**RE: Bank of Oklahoma – 6301 Jefferson
Grading and Drainage Plans
Engineer's Stamp Date: 12/14/23
Hydrology File: E17D016C**

Re: *Bank of Oklahoma – 6301 Jefferson
Grading and Drainage Plans
Comment Responses to December 6, 2023 comments*

RE: BOKF – Albuquerque
Hydrology Submission

OVERALL GRADING &
DRAINAGE PLAN

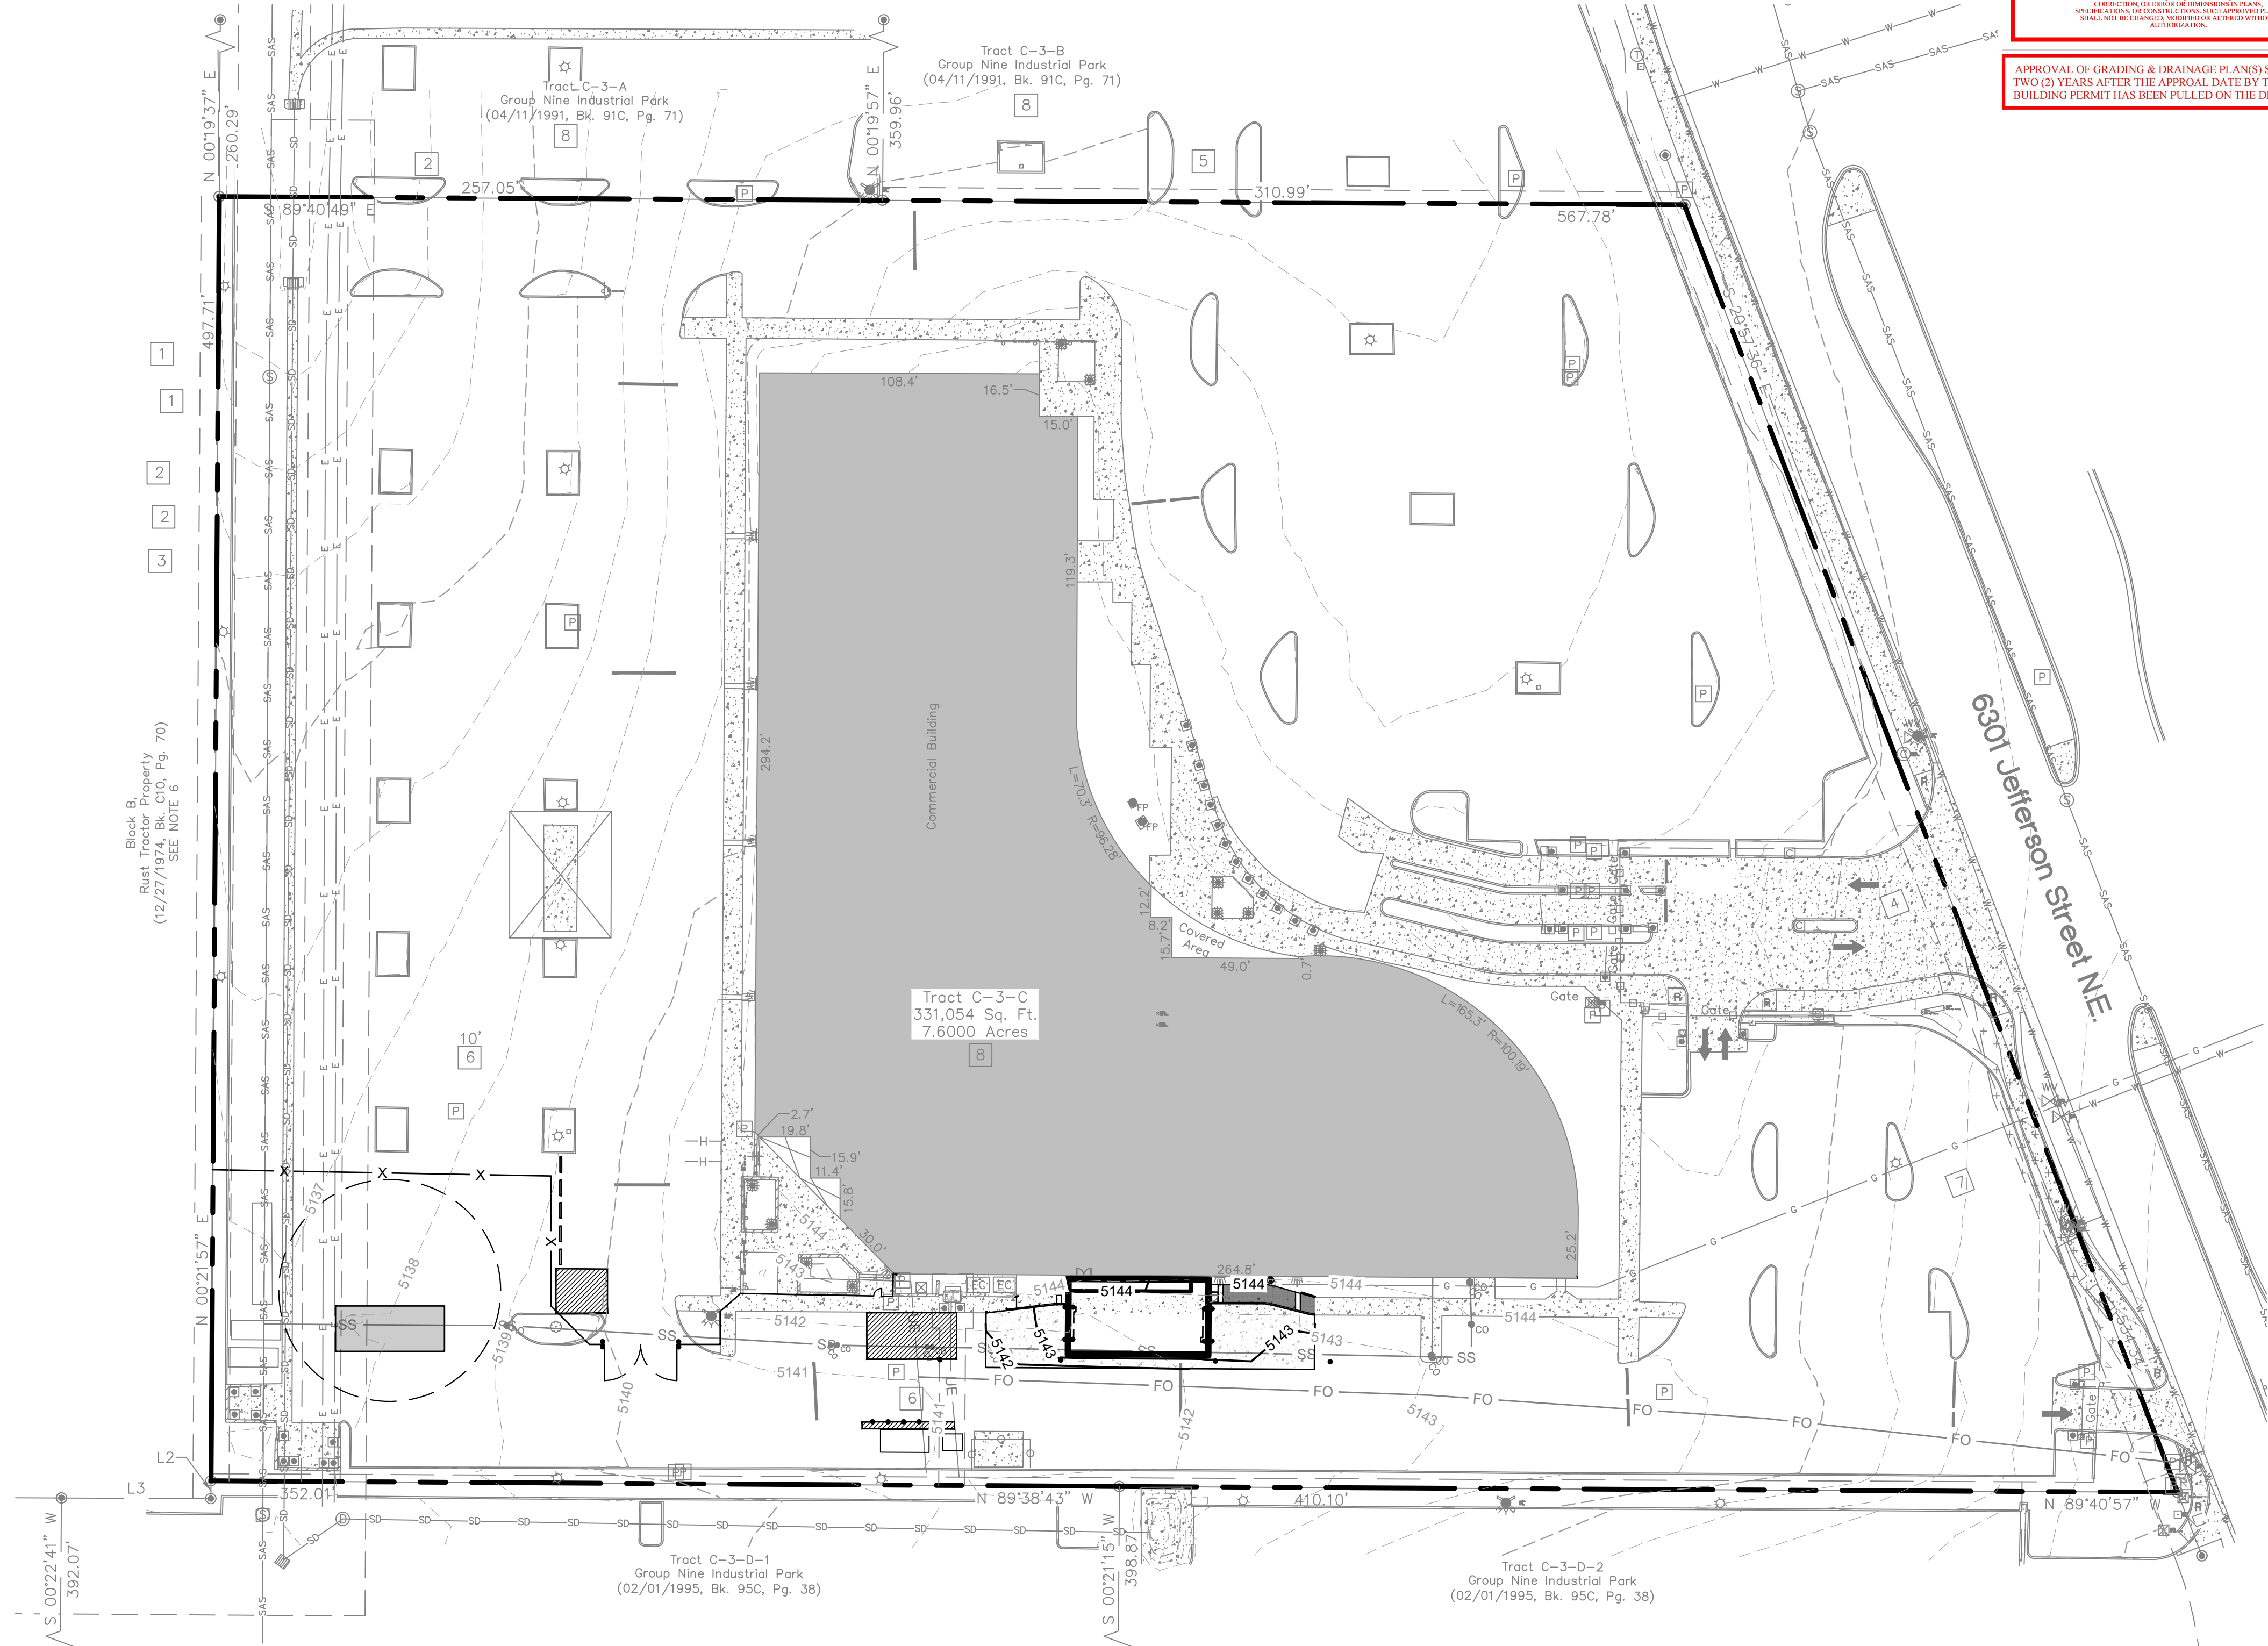
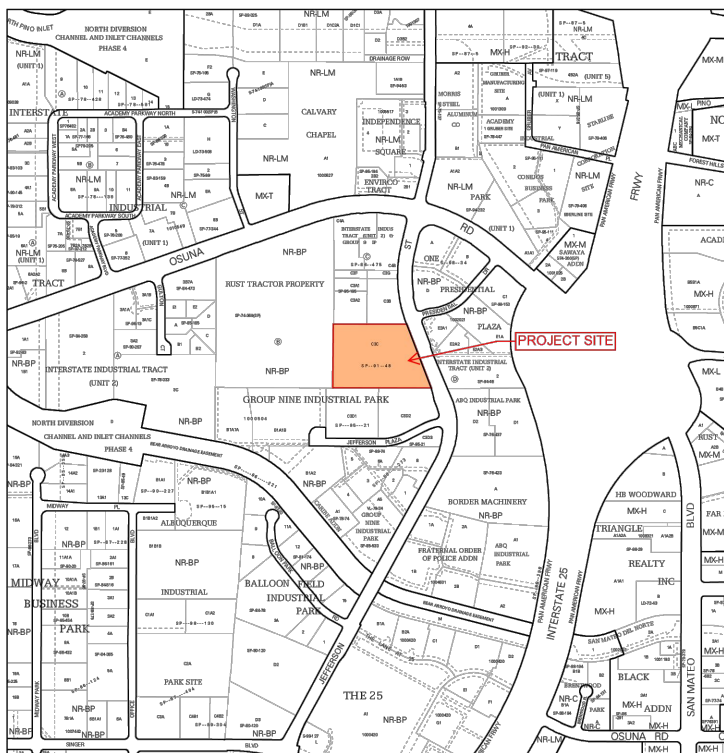
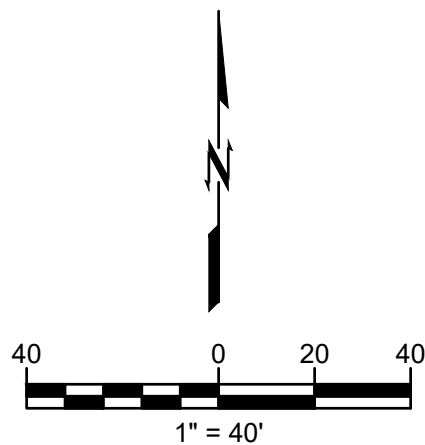
1. Per the DPM, the following must be on the Grading Plan. Please note the Grading Plan must be a stand-alone construction document.
 - a. Please provide a Vicinity Map. Typically, this is the Zone Atlas. This can be downloaded in pdf format from the City of Albuquerque's website.

- b. Please provide the Benchmark information (location, description and elevation) for the survey contour information provided.
 - c. Please provide the FIRM Map and flood plain note with effective date.

- d. Please provide a legal Description of the property.
 - ***Response: A zone atlas map has been provided in the upper right corner of both sheets. The benchmark information is provided in the upper corner of the sheets. A floodplain note has been added on the Grading and Drainage Plans. A legal description has also been listed.***

2. Please place all the topographic information that CSI provided on the overall Grading & Drainage Plan. Then the second sheet can be the closeup view of the proposed building. (C500) Please show the existing finish floor of the building to be 5144.6' on the plans. These are the only two that Hydrology needs to approve.

6. Please add a note which states, "The Owner has elected to pay the Payment in Lieu for the required Stormwater Quality Volume. The Payment in Lieu Amount = $\text{XXX CF} \times \$8/\text{CF} = \XXX.00 ".

- ***Response: Acknowledged. New Grading and Drainage plans have been created that have an overall and zoomed in view. The FFE above has been listed on the existing building in both sheets.***

- ***Response: Acknowledged. This note is added on the Overall Grading & Drainage Plan (C500).***
